## **Michael Calabro Pty Ltd**

Construction of a 12 storey building comprising 11 levels of student accommodation, ground level retail tenancies and at grade and basement car parking.

### **13-17 Metro Parade, Mawson Lakes**

361/L020/20

Figure 2 subject site distance 17 metres from aqua apartment building

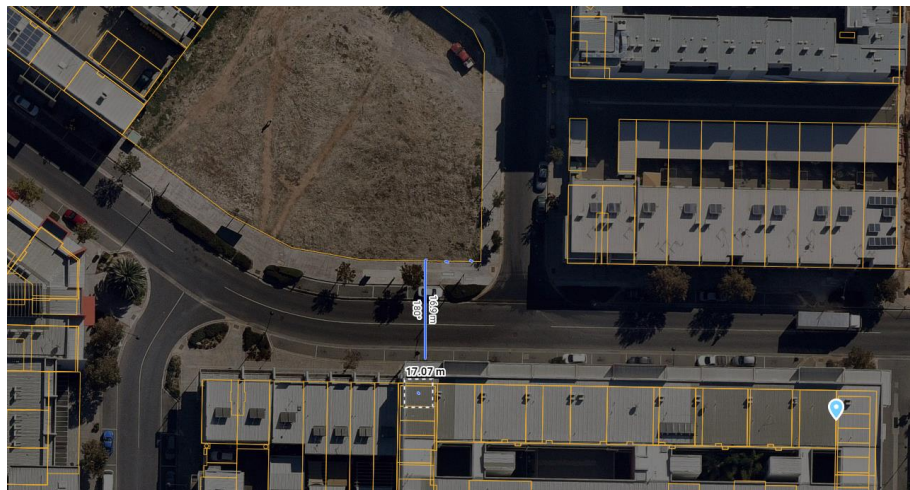
- 1.1 The aerial image in Figure 2 below illustrates it is a mere 17 metres from the front façade of this building to the northern roof edge and the private outdoor space balconies of our Aqua apartment at 6-10 Metro Parade, as shown by blue line .

**Figure 4** policy area 22 includes Metro Parade

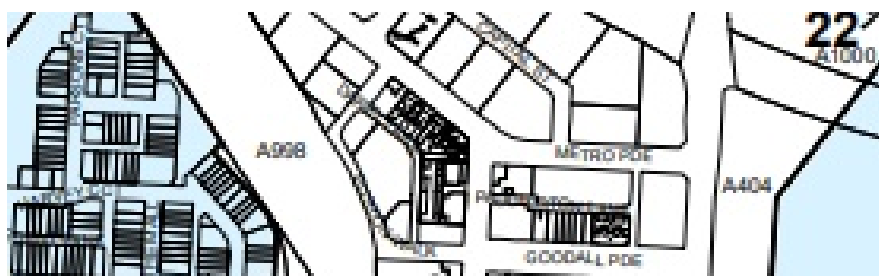
2.2 The current City of Salisbury Development Plan Policy area 22 includes Metro Parade as shown in figure 4; this requires objectives:

**Figure 5** Congested access lane with parking spaces adjacent bin storage and collection area.

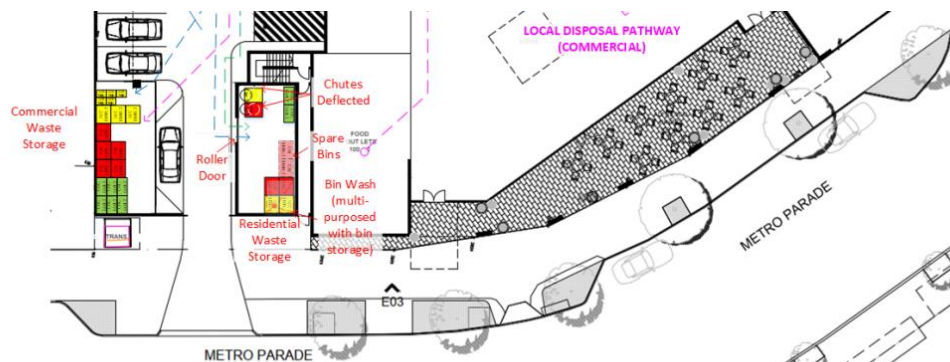
6.1 The site's Metro Parade ingress is located within the 'prohibited access location' area identified by AS/NZS 2890.1:2004. The close proximity of the site access to the existing T junction of Garden Terrace with Metro Parade is likely to create additional accidents especially due to the poor design and conflicts within the access area. As shown in figure 5 and figure 6 below there is a congested bin and parking area with bins on both sides of the access lane with no separation from adjacent parked vehicles. Vehicles reversing out of the parking spaces are likely to be turning or reversing into the lane at the same time as vehicles, including large refuse vehicles, are quickly crossing Metro Parade into the access lane to avoid oncoming traffic on Metro Parade. The potential for accidents at the access lane and Metro Parade at this location appears to be high due to poor design and traffic conflicts.

**Figure 7** Parafield Airport runways located less than 1400 metres from proposed 12 storey building.

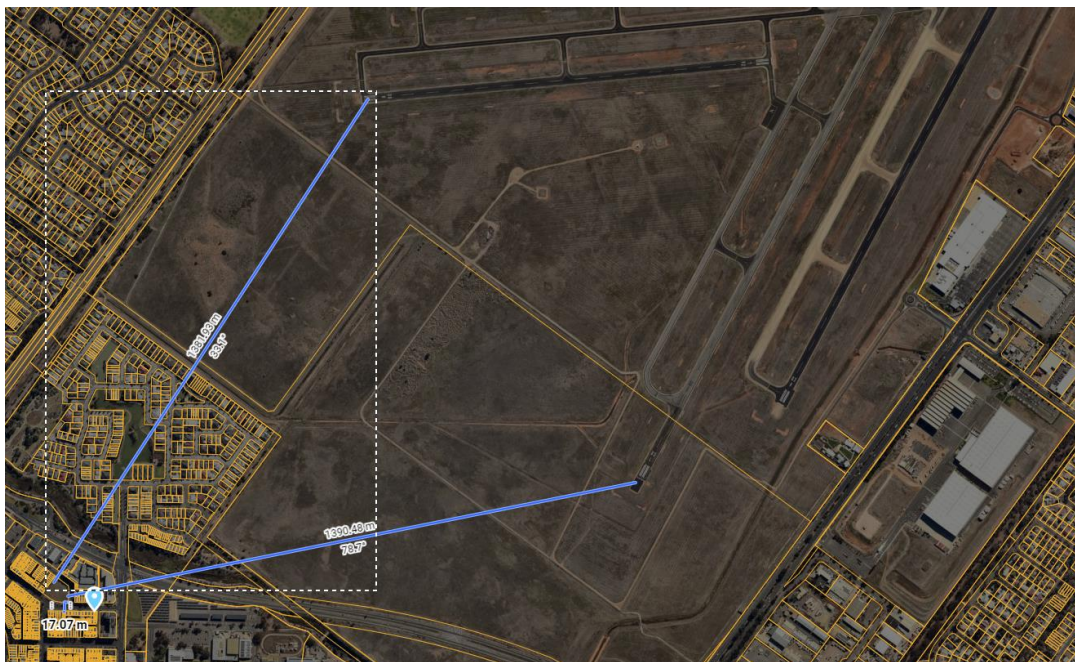
8.2 Trainee pilots should not have a hazard placed in close proximity to their runways and flight paths. The height and wind impacts of this proposed development may impact and affect safety for trainee pilots and so local residents. The development site is actually less than 1400 metres from two of the Parafield airport runways, as shown in Figure 7.

**Figure 8** Extract from City of Salisbury Development Plan map Sal47 showing airport zones

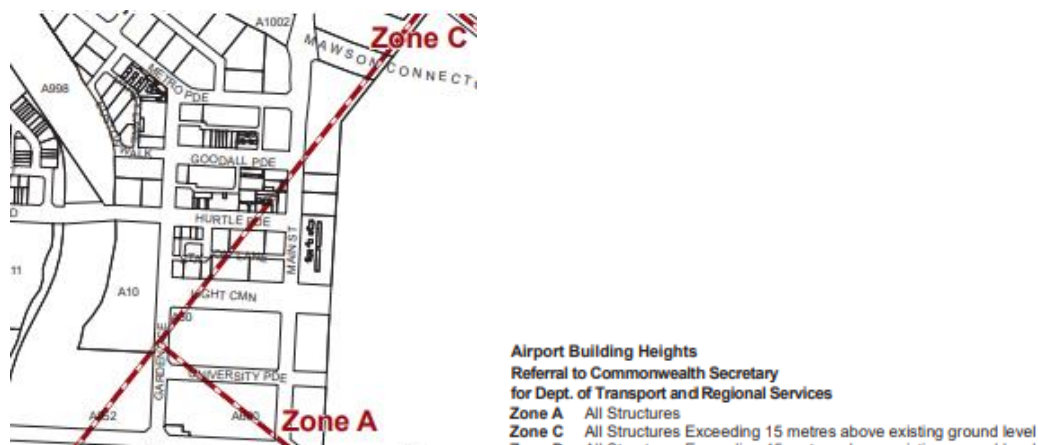
8.3 According to MAP Sal47, it appears the Metro Parade development site is less than 200 metres from Zone A and is located in Zone C, not in zone D. Existing buildings on Metro Parade have required permits for cranes to place air-conditioning equipment on roofs.

**Figure 1: Cross-Section of the Internal Courtyard**

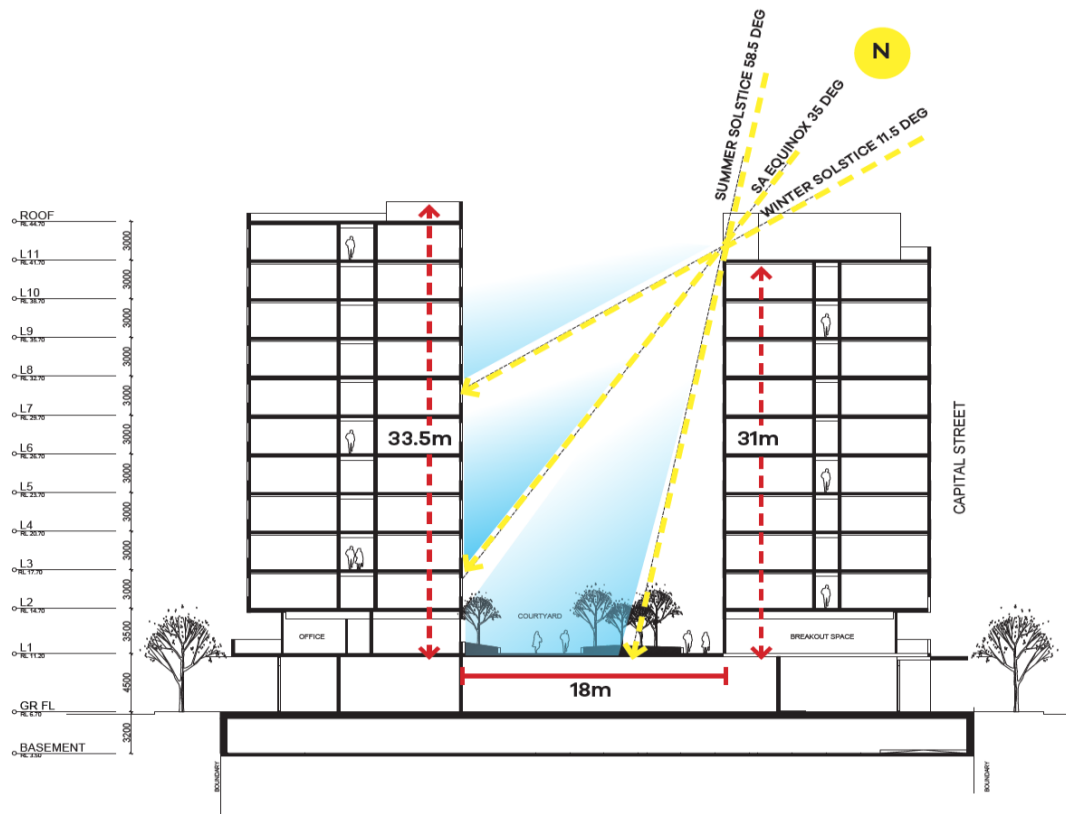
- the primary purpose of this space is to provide natural light and ventilation to all of the ‘internal’ rooms, and to ensure that the prospective occupants of these rooms have a pleasant outlook, as sought by Clause (d) of Principle 19 of the ‘Medium and High Rise Development’ Module;
- this space is secondary to the rooftop terrace and supplemented by another 10 communal/breakout spaces across Levels 1 through to 10; and
- this space is most likely to be used during the months of summer and Figure 1 below clearly demonstrates that sunlight will reach its surface during this period of the year.

**Figure 1: Overlay Map Sal/47 (Development Constraints)**

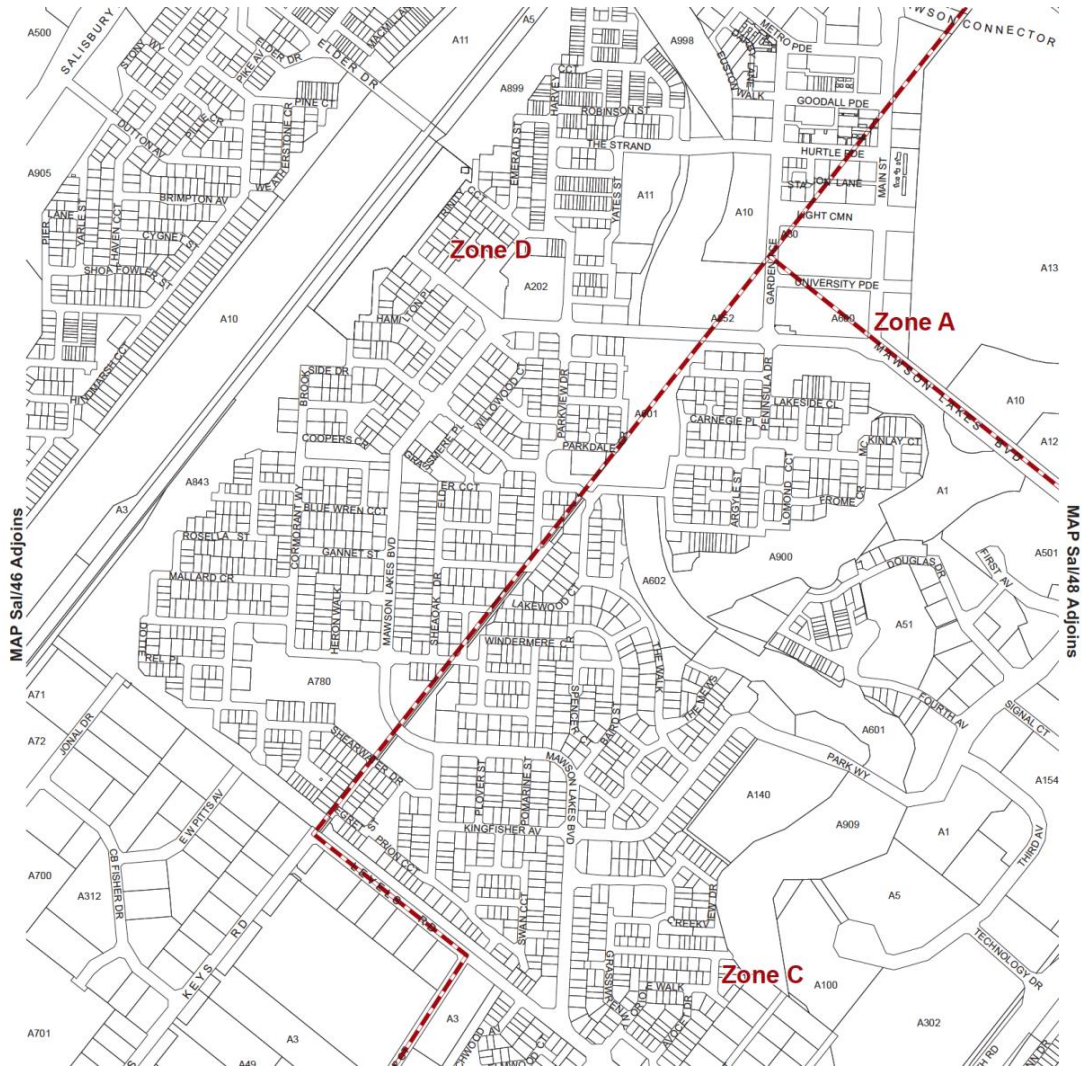
With all due respect to this representor, it is clear from Overlay Map Sal/47 (Development Constraints) and Figure 1 overleaf that the site falls within the ambit of 'Zone D' which, put simply, means that the proposed building need not be referred to the Commonwealth Secretary, as it will not exceed 45 metres in height.
